Shielding RAIs**RAI 6-4:**

Criticality RAIs**RAI 7-1:**

Figure RAI 8-6-1
Reduction factors for modulus of elasticity at elevated temperatures

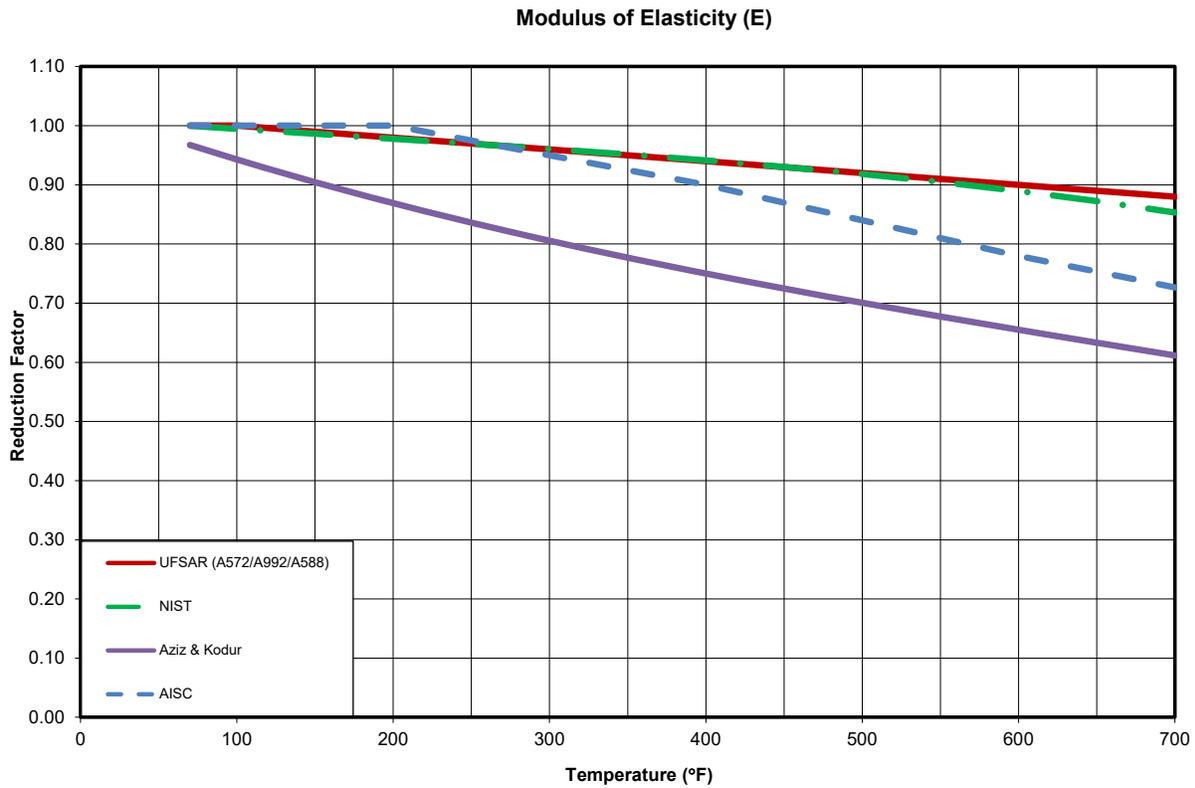
Provide the following additional information for UFSAR Tables A.8-2, A.8-3 and A.8-4 which apply to ASTM A572 Grade 50, ASTM A992 Grade 50, and ASTM A588 steels respectively:

1. Justify the methodology used to estimate the mechanical properties of these steels at elevated temperatures.

There are several established methodologies used to estimate the elevated temperature mechanical properties of structural steel. Sief et al., (2016) reviewed elevated temperature properties for structural steels and compared the estimated values from several models to actual data for the elastic modulus, yield strength and tensile strength (NIST Technical Note 1907 Figures 2-3, 2-4 and 2-6 respectively). Sief et al., (2016) showed significant variations in the mechanical properties of structural steels as well as variations in the predicted values of models used to estimate the mechanical properties at elevated temperatures.

Figures RAI 8-6-1, RAI 8-6-2, and RAI 8-6-3 show *four* temperature-dependent reduction factors based on the following four different sources, for the elastic modulus (E), yield strength (F_y), and tensile strength (F_u), respectively (Note that for temperatures up to 700 °F, 250 °F is the bounding temperature for the HSM-MX DSC support pedestal/stop plate and axial retainer rod for the normal and off-normal conditions (UFSAR Figures A.4-21 and A.4-22)):

Figure RAI 8-6-1 shows that the temperature-dependent values of modulus of elasticity used in the UFSAR are in very good agreement with those from NIST Technical Note 1907 [2], but greater than those from Aziz and Kodur [3] throughout the entire temperature range. *The UFSAR modulus of elasticity is slightly lower than the AISC [4] values for the temperature lower than 250 °F, but higher above 250 °F.* Figure RAI 8-6-2 shows that the temperature-dependent values of yield strength used in the UFSAR are less than those from NIST [2], Aziz and Kodur [3], and AISC [4] for the entire temperature range, with the exception that the UFSAR values are slightly greater than those from NIST [2] for a very high temperature range (> 600 °F). Figure RAI 8-6-3 shows that the temperature-dependent values of tensile strength used in the UFSAR are in good agreement with those from NIST [2], Aziz and Kodur [3], and AISC [4] for temperatures less than 400 °F. *Since 250 °F is the bounding temperature considered in the structural evaluations of the HSM-MX components made of the three steels, those observations made above for temperatures greater than 250 °F have no implications in this response.*

Figure RAI 8-6-2
Reduction factors for yield strength at elevated temperatures

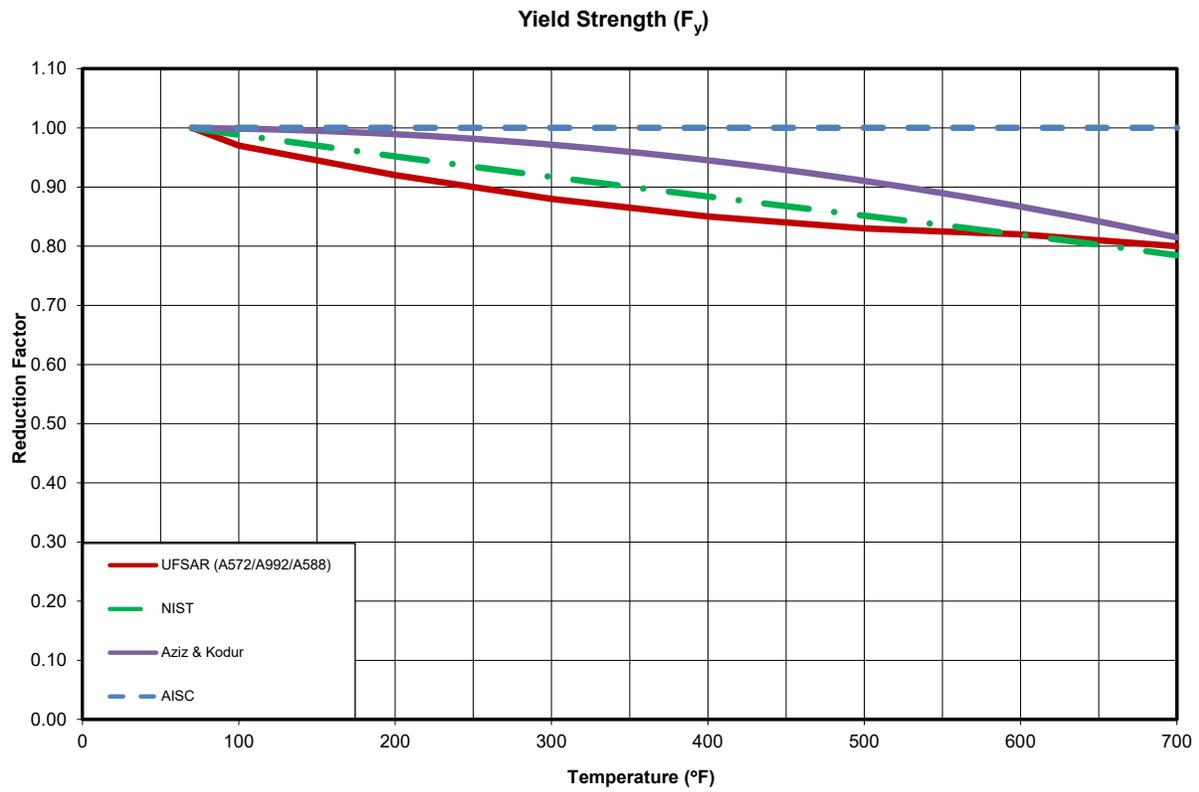
2. Provide allowable stress values for these materials as a function of temperature, a technical basis for the determination of the allowable stresses and an analysis showing that the actual stresses do not exceed the allowable stresses.

Tables A.8-2, A.8-3 and A.8-4 for ASTM A572 Grade 50, ASTM A992 Grade 50, and ASTM A588 steels, respectively, contain information on the predicted values of yield and tensile stresses and elastic modulus. Allowable stresses for these materials are not provided and the analyses conducted do not include an assessment of the actual stresses compared to the allowable stresses as a function of temperature.

- The tensile and shear strengths rely on the yield strength. As shown in Figure RAI 8-6-2, the yield strengths used in the UFSAR are less than those proposed by NIST [2], Aziz and Kodur [3], and AISC [4] for the temperature under 600 °F. Therefore, the mechanical property values used in the UFSAR for the tensile and shear strengths are conservative.
- The compressive strength relies on both the yield strength and modulus of elasticity. According to the AISC steel construction manual [4], the critical stress F_{cr} for compressive strength, for $KL/r \leq 4.71 \sqrt{E/F_y}$, is:

Since the allowable tensile and shear stresses are directly related with the yield strength, their temperature-dependent variations follow the same curve, which is shown in Figure RAI 8-6-2. Similarly, since the allowable compressive stress is directly related to F_{cr} , its temperature-dependent variation also follows the same curve as shown in Figure RAI 8-6-4. As demonstrated in the response to Part 1 of this RAI, these properties are based on conservative estimations of the mechanical properties for the three steels at elevated temperatures.

Figure RAI 8-7-1
HSLA Steel Qualification and Acceptance Tests

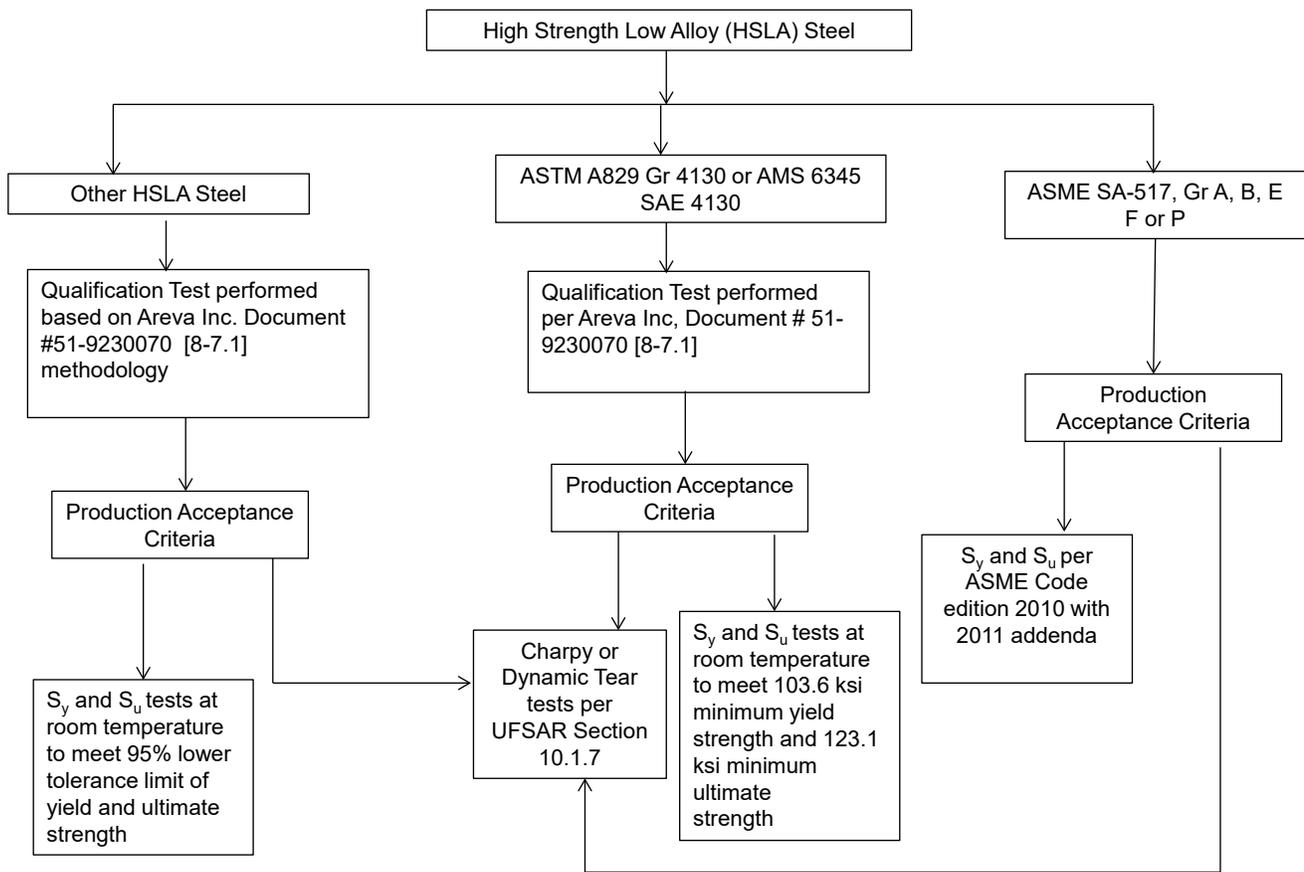
Provide allowable stress values for ASTM A829 Gr 4130, AMS 6345 SAE 4130 and other HSLA steels as a function of temperature, a technical basis for the determination of the allowable stresses and an analysis showing that the actual stresses do not exceed the allowable stresses. ASTM A829 Gr 4130 or AMS 6345 SAE 4130 and other HSLA steels are identified in UFSAR Section 10.1.7. UFSAR Table 8-10 contains information on the predicted values of yield and tensile stresses and elastic modulus. Allowable stresses for these materials are not provided and the analyses conducted do not include an assessment of the actual stresses compared to the allowable stresses as a function of temperature.

The material qualification and production acceptance tests for HSLA steels, ASME SA-517 Gr. A, B, E, F, or P, and other HSLA steels are presented in the flow chart in Figure RAI 8-7-1 in support of this response.
